**Board of Adjustment
Special Meeting Agenda
Fraser Town Hall, 153 Fraser Avenue
Wednesday February 26, 2025
5:30 PM - 6:30 PM**

a. Appeal Of Administrative Variance Denial - The Ascent

MAJOR SITE PLAN
THE ASCENT

RE: The Ascent – Final Plat, Major Site Plan, Administrative Variance
Planning Review Comments (1st Referral Review)

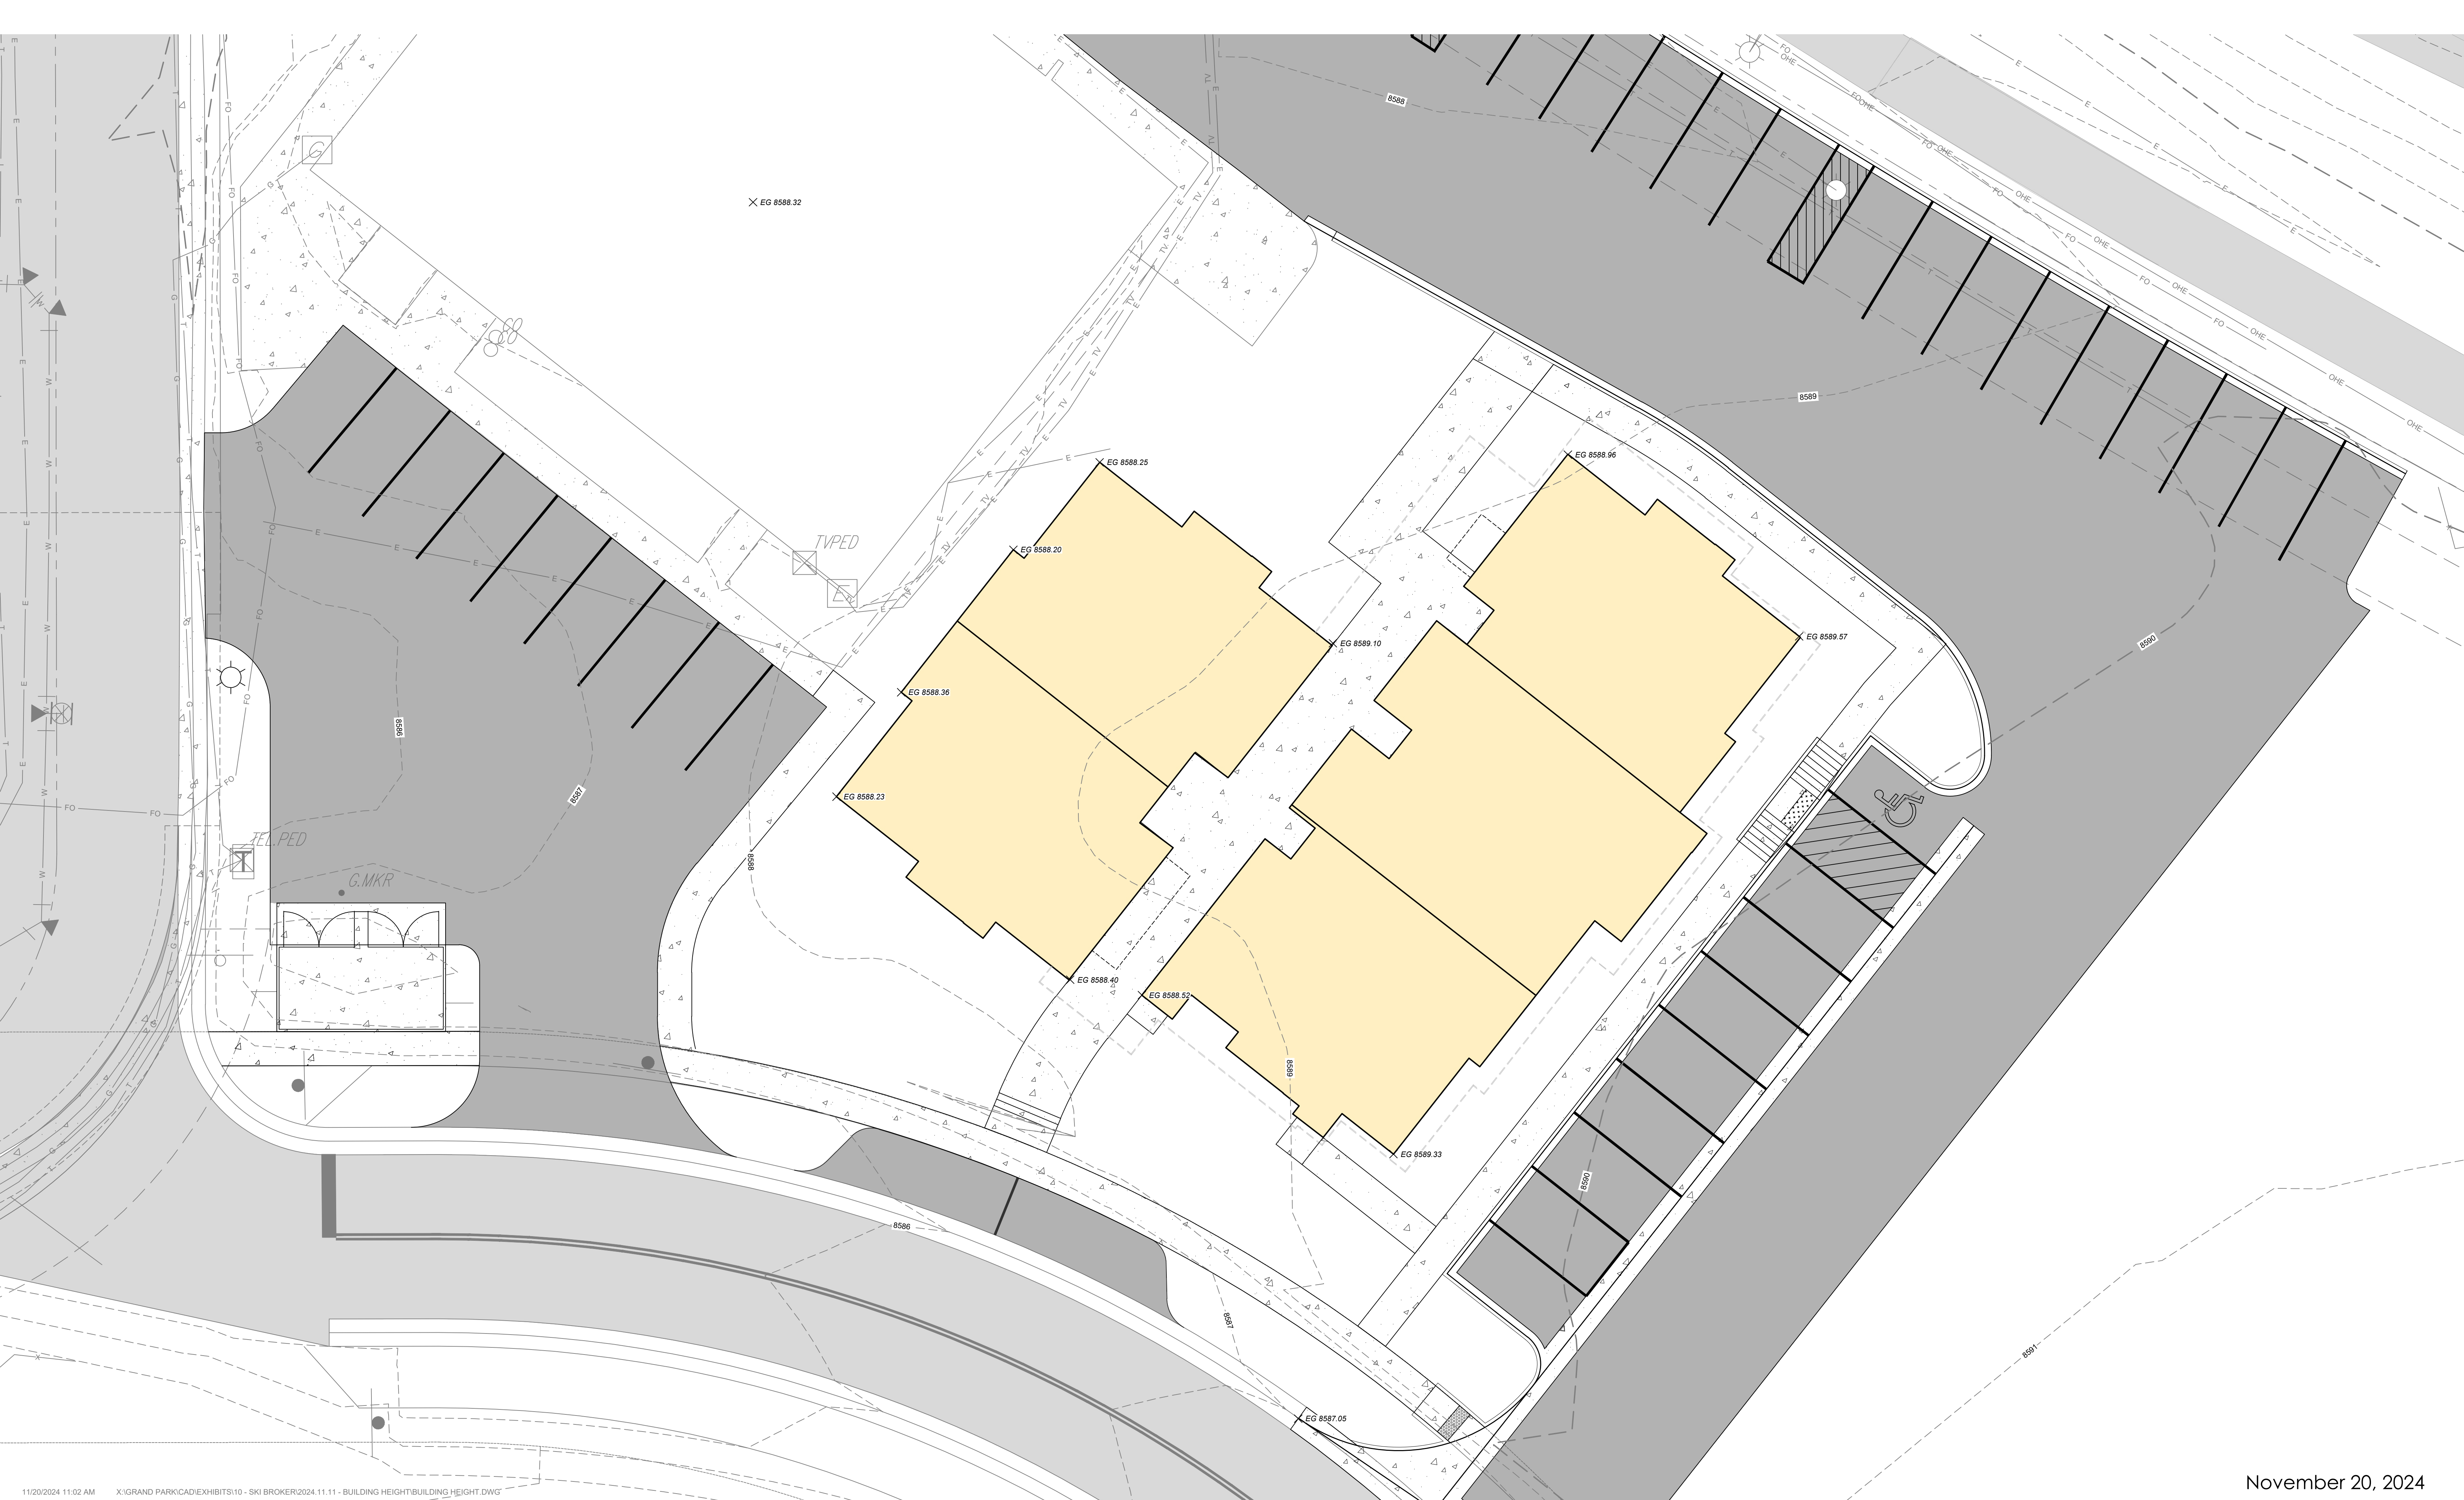
As defined above and applied to this request, building height is measured from the mid-point of the pitched portions of the roof to the lowest existing elevation of any one side of a building. In practice, generally the preconstruction elevations are going to be the lowest, unless additional excavation and grading is proposed as part of a development. The applicant's proposed building elevations with height measurements are provided below and depict the lowest existing grade as 1.7 ft. below the finished floor elevations. Full plan documents are provided as an attachment to this report for closer examination.

The building is designed in such that it is essentially two separate building footprints connected by an open-air common hallway with stairs; see the site plan for the proposed Lot 3 on the following page for reference. The southeast portion of the building has a larger footprint, is three stories in height, and has three residential units per floor. The northwest portion of the building has a smaller footprint, is four stories in height, and has two units per floor. It is this northern portion of the building that exceeds the forty-five foot height maximum. The majority of this part of the structure, including floor plates of all four floors, are under the height maximum, but the slightly slanted roof is fully above the maximum, with the mid-point measured at 49.5 ft. from the lowest existing grade.

SITE PLAN
January 29, 2025
SHEET 2

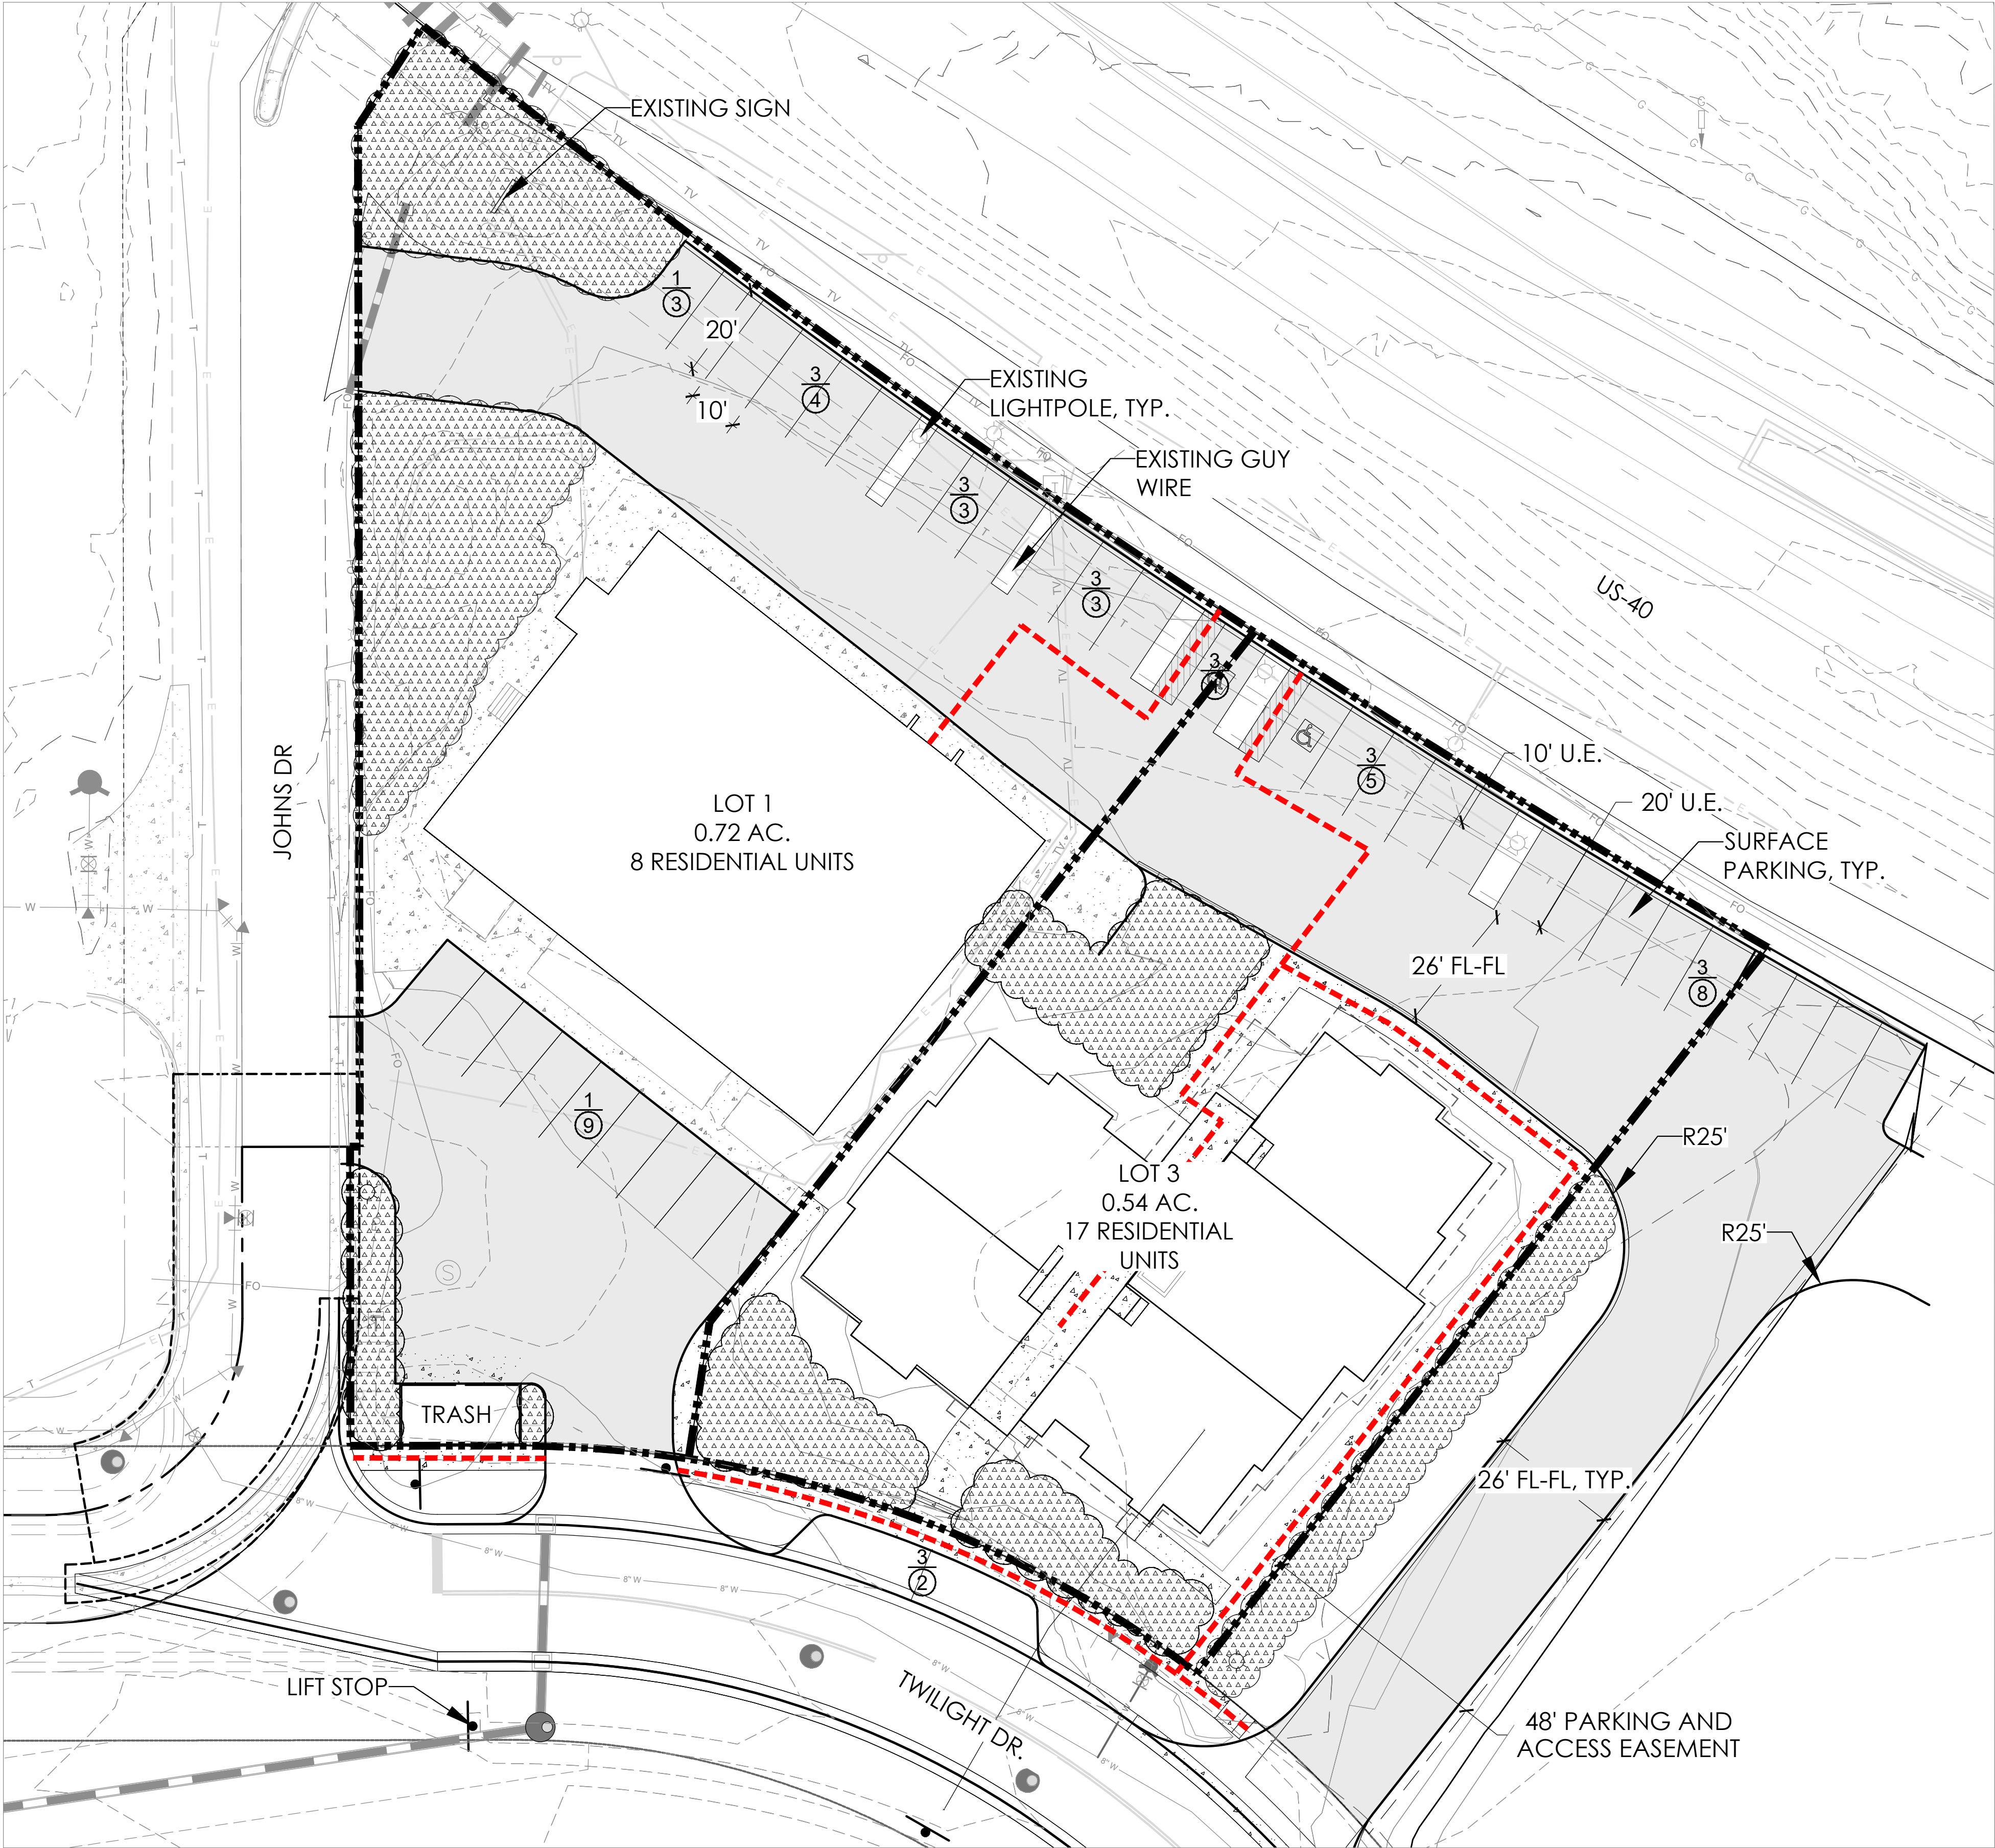
Sheet 2 – Site Plan

- 24) Provide a trash enclosure detail showing conformance with [Sec. 19-4-160\(b\)](#), i.e., label the enclosure color and materials to ensure they are consistent with those of the main building.

- 25) Include a summary of unit types by bedroom count or note that all units will be two-bedroom units.
- 26) Note or provide in the data table the number of bedrooms in the existing two units in the XSports building since there will be shared parking between the lots.

- 28) Please add a note that the two parallel spaces proposed along “Victory Rd” within the proposed ROW are included in the provided parking count.
- 29) Data table lists Lot 1A and 2B. Should be 1A and 1B unless the lots are renumbered to Lot 1 and Lot 3 as requested by staff.

- 30) Please remove floor plan linework from building footprints for clarity.
- 31) In September 2024, the Town adopted by reference the 2023 Colorado Model Electric Ready and Solar Ready Code. The site plan must display compliance with applicable requirements of this code before building permits are issued. Please designate on the parking plan at least a minimum number of EV spaces per the requirements below. Definitions for each category of EV capability are found in Chapter 2 of the referenced code. Multifamily residential is found on page 25 and must include the following:
